SUBJECT: Guilford County; Greensboro Eastern Loop from US 70
Relocation to SR 2303 (Lawndale Drive);
WBS No. 38421.1.1; **TIP U-2525B & C.**

Attached are modifications to the US Army Corps of Engineers Section 404 Individual Permit, the NC Division of Water Resources Section 401 Water Quality Certification, and the Jordan Lake Buffer Rules. Except as revised here, the permit conditions of the original U-2525 permits and subsequent modifications remain valid.

Subject: Modification to the 401 Water Quality Certification Pursuant to Section 401 of the Federal Clean Water Act and Jordan Lake BUFFER RULES with ADDITIONAL CONDITIONS for Proposed Greensboro Eastern Loop from US 70 Relocation to SR 2303 (Lawndale Drive) in Guilford County; WBS Element No. 34821.1.1; TIP U-2525BC. NCDWR Project No. 20130918 v.9; Certification No. 3978.

**Modification to the 401 Water Quality Certification Pursuant to Section 401 of the Federal Clean Water Act
and Jordan Lake Watershed BUFFER RULES with ADDITIONAL CONDITIONS**

U-2525C MOD SITE 1

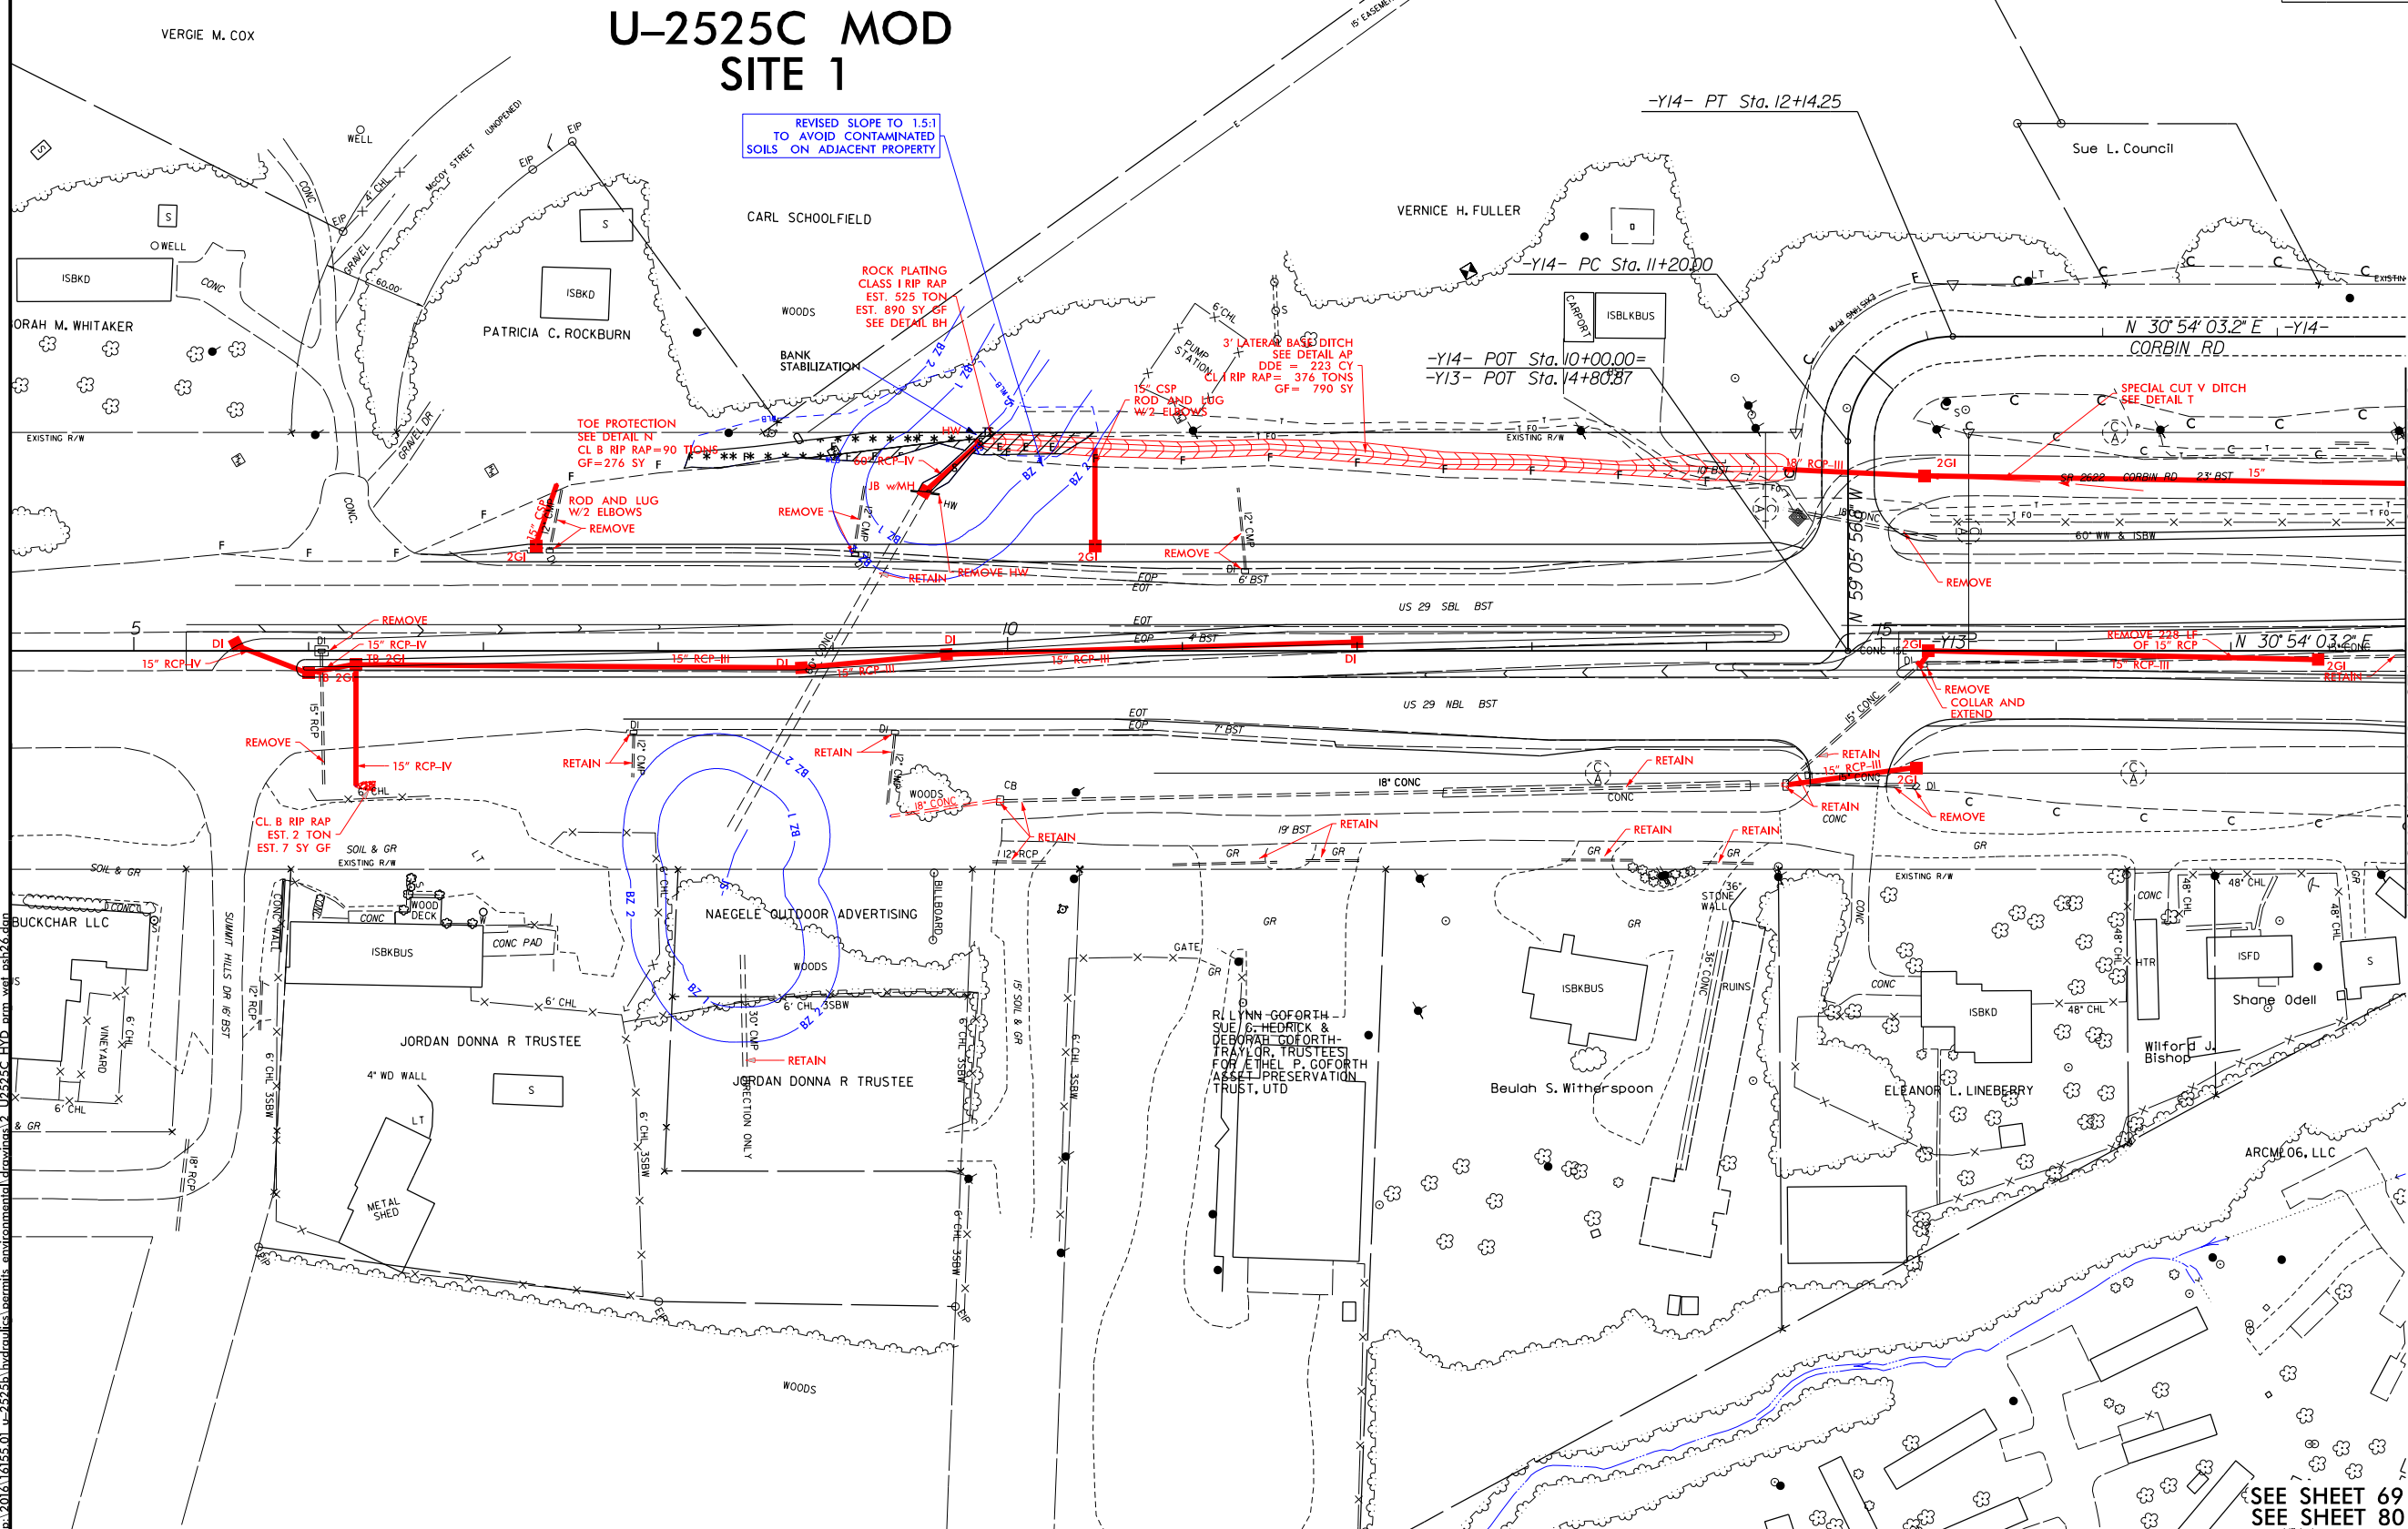
- 1) Permit Site 1 - Authorization of a permanent discharge of dredged or fill material into 46 linear feet of stream channel and 0.08 acre of riparian non riverine wetlands, as well as the temporary discharge of fill material into 5 linear feet (0.01 acre) of stream channel, related to:

- a. Extending an existing 60" concrete pipe into 41 linear feet of stream channel (permanent loss of waters), adding 5 linear feet of rip rap bank stabilization below the pipe, and requiring 5 linear feet of impacts for temporary construction access and dewatering, and;

- b. Adding new roadway slopes needed to incorporate a lengthened collector/distributor lane requiring 0.03 acre of permanent wetland fill, 0.02 acre of excavation to relocate the existing roadside ditch, and 0.03 acre of mechanized clearing for installation of sediment and erosion control measures. A portion (0.02 acre) of the 0.03 acre of permanent wetland impacts is a result of the potential lateral wetland drainage from the new lateral base ditch;

REVISED SLOPE TO 1.5:1
TO AVOID CONTAMINATED
SOILS ON ADJACENT PROPERTY

U-2525C MOD SITE 1 ENLARGEMENT

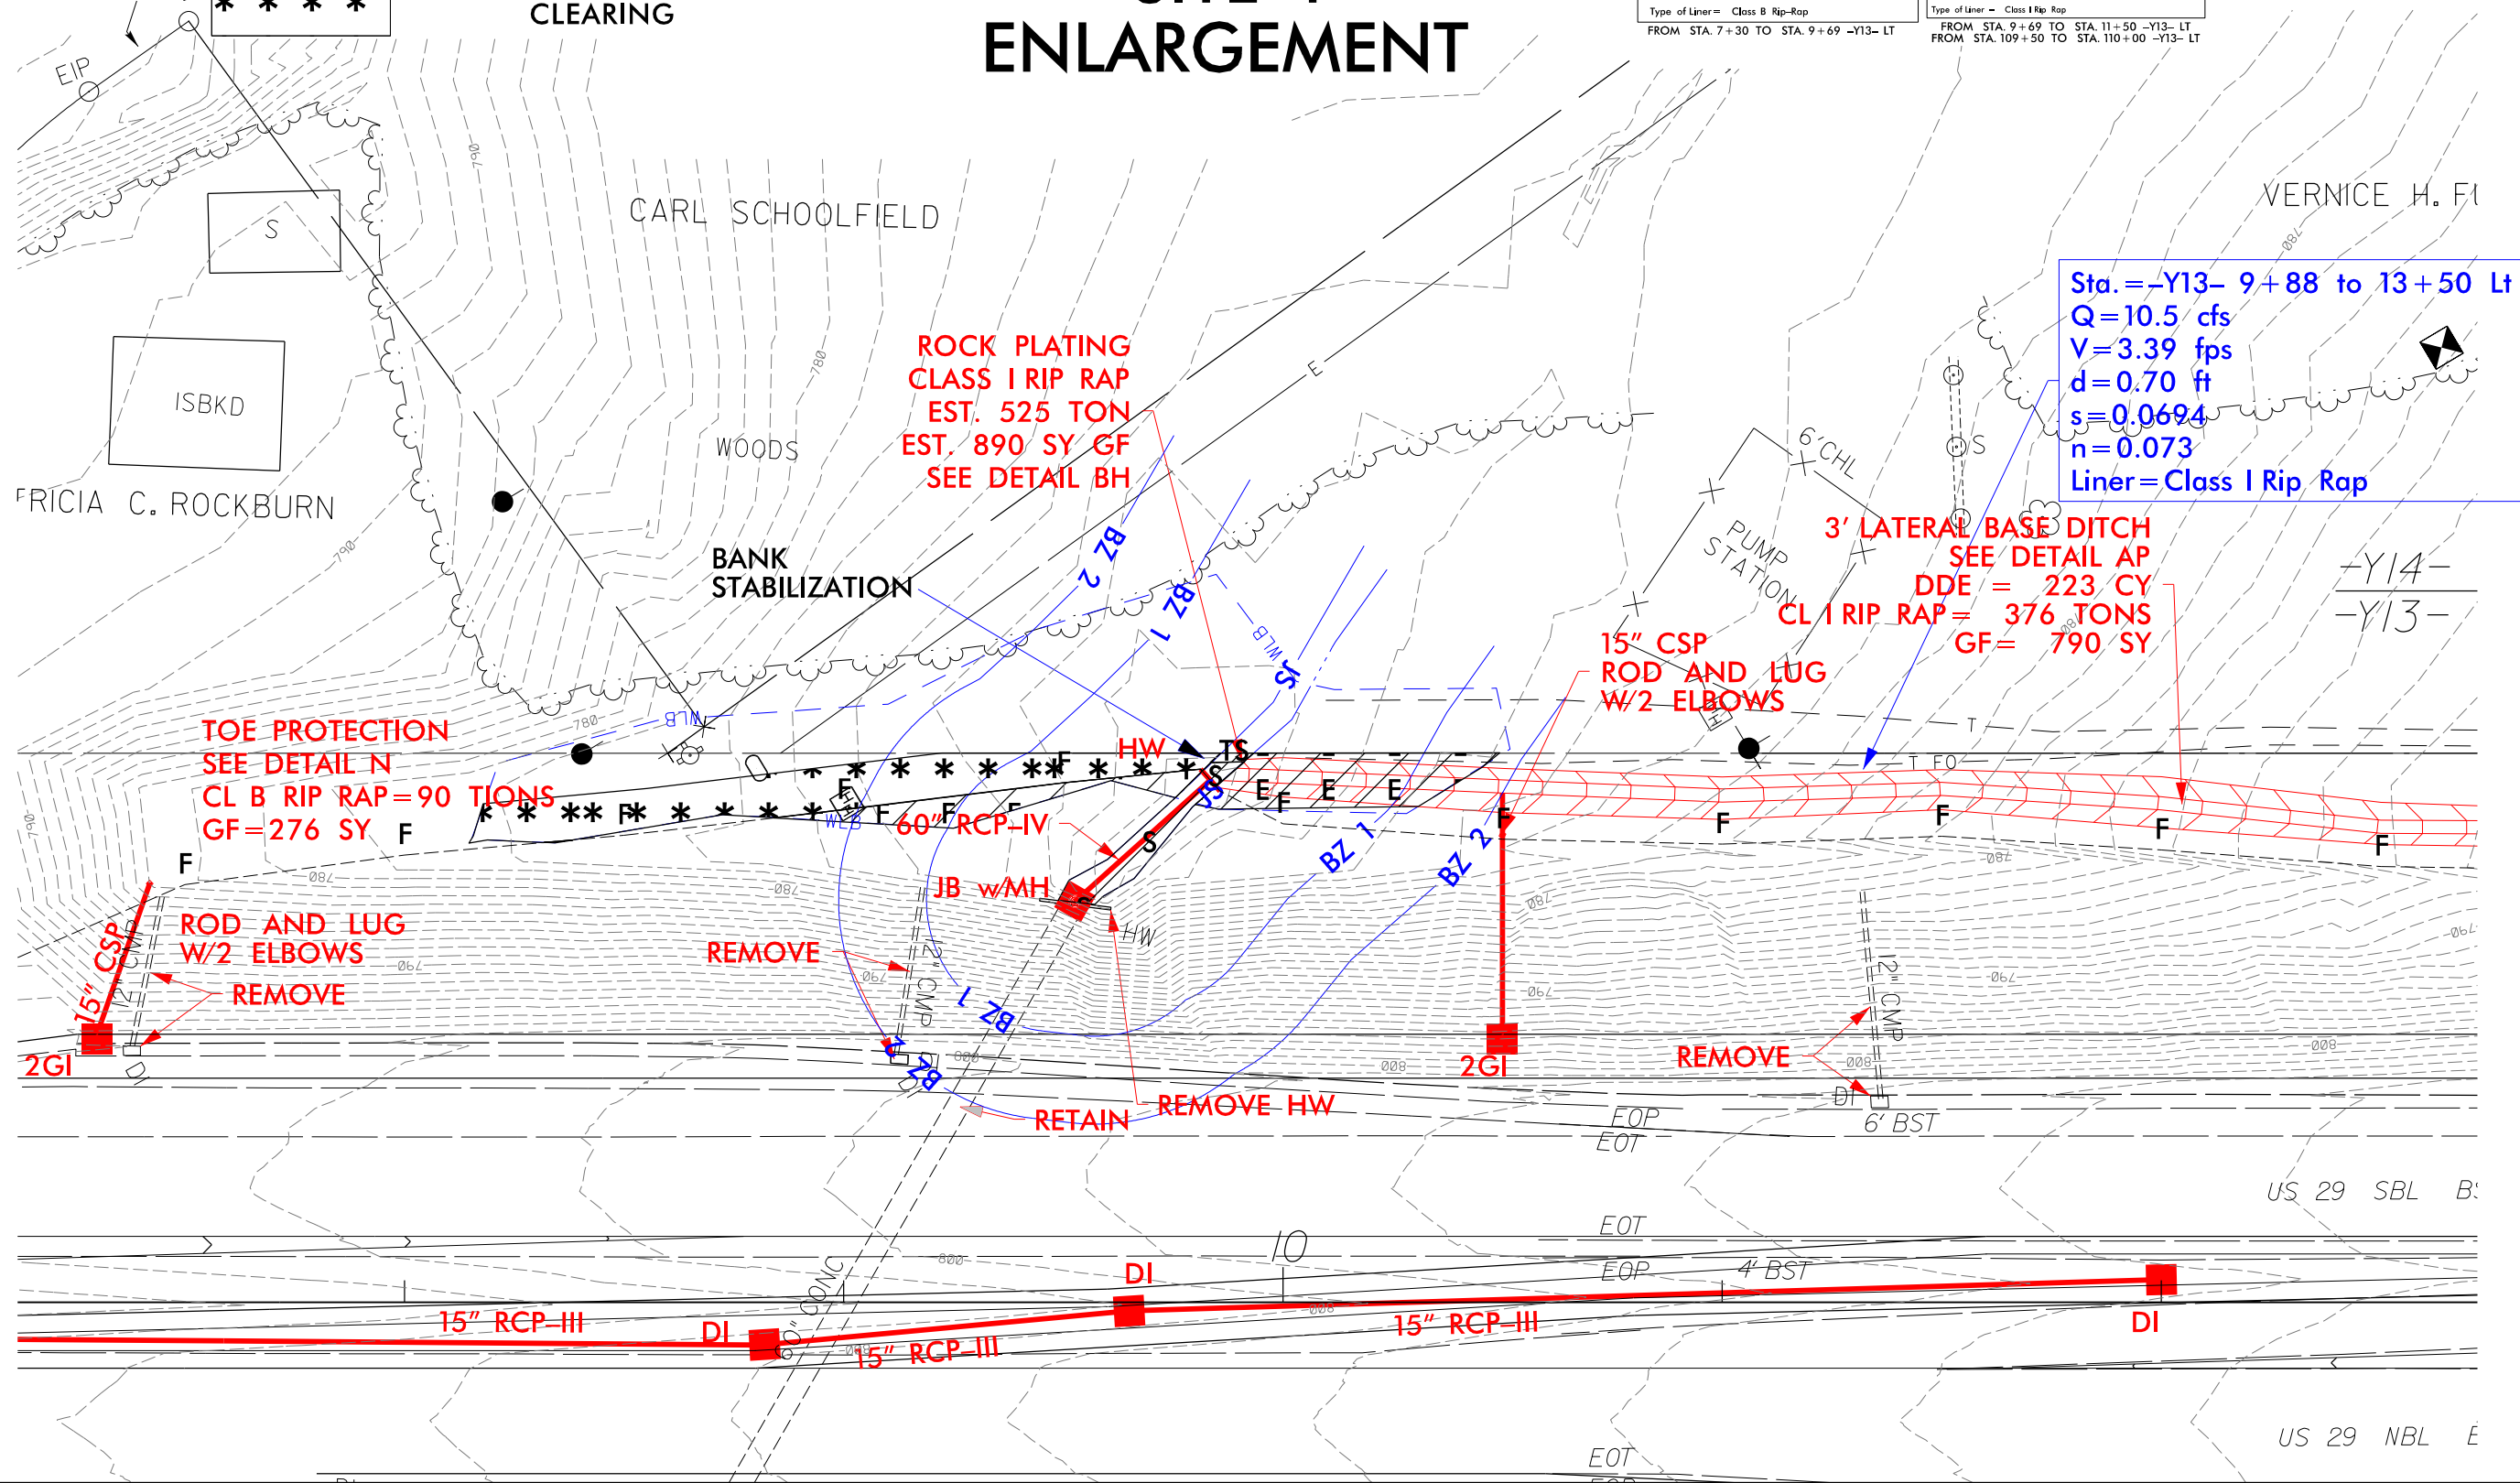
Sta. = -Y13- 9+88 to 13+50 Lt
Q=10.5 cfs
V=3.39 fps
d=0.70 ft
s=0.0694
n=0.073
Liner= Class I Rip Rap

U-2525C MOD
SITE 2

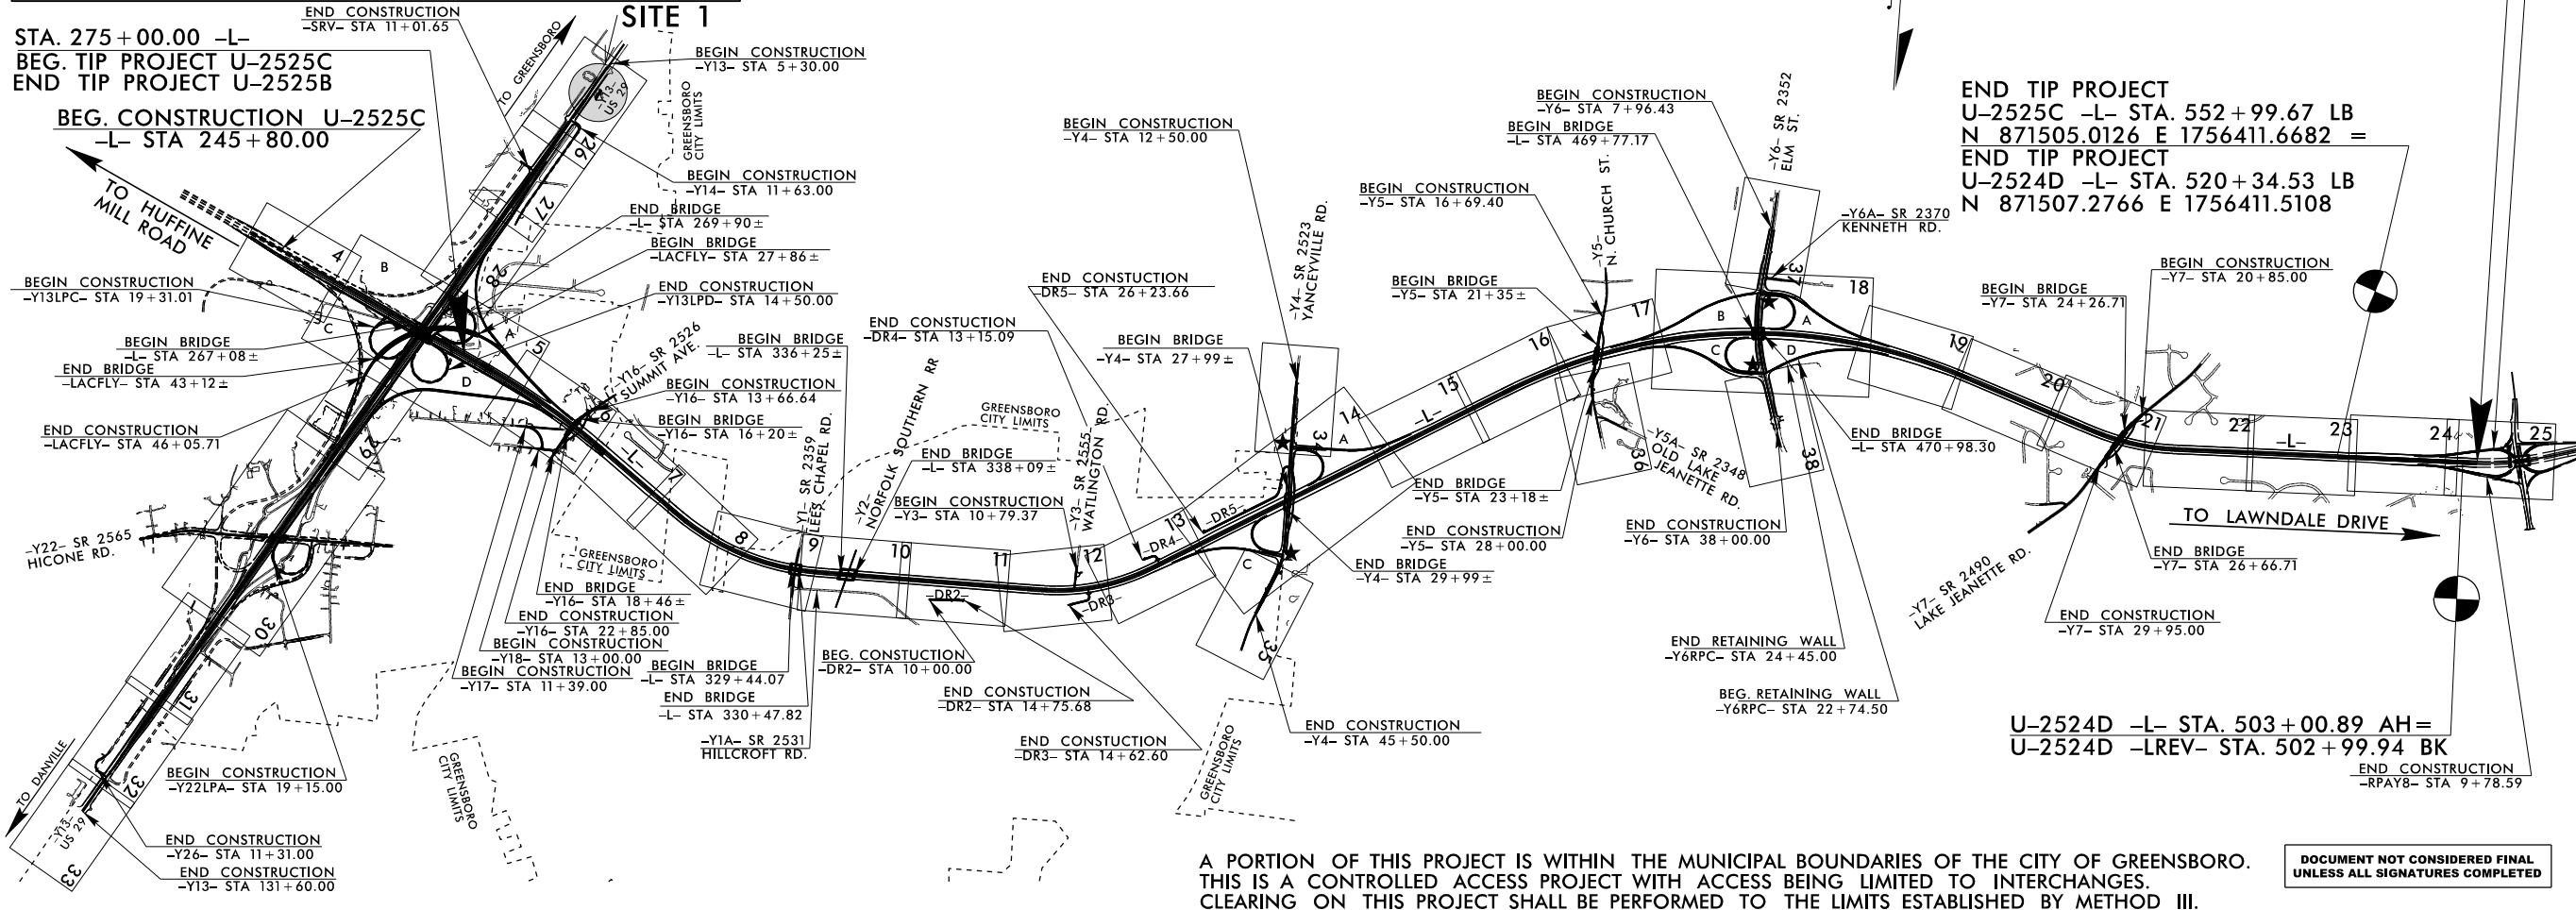
- 2) Permit Site 2 - Authorization of a permanent discharge of dredged or fill material into 362 linear feet of stream channel and 0.46 acre of riparian non riverine wetlands, related to constructing a ramp in the northwest quadrant of the US 29 interchange:

- b. This action involves impacting the remaining portion of wetland WE, including 0.43 acre of permanent wetland fill and 0.03 acre of excavation. Note that a portion (0.15 acre) of this permanent fill was previously permitted as mechanized clearing as part of U-2525B, Site 21.
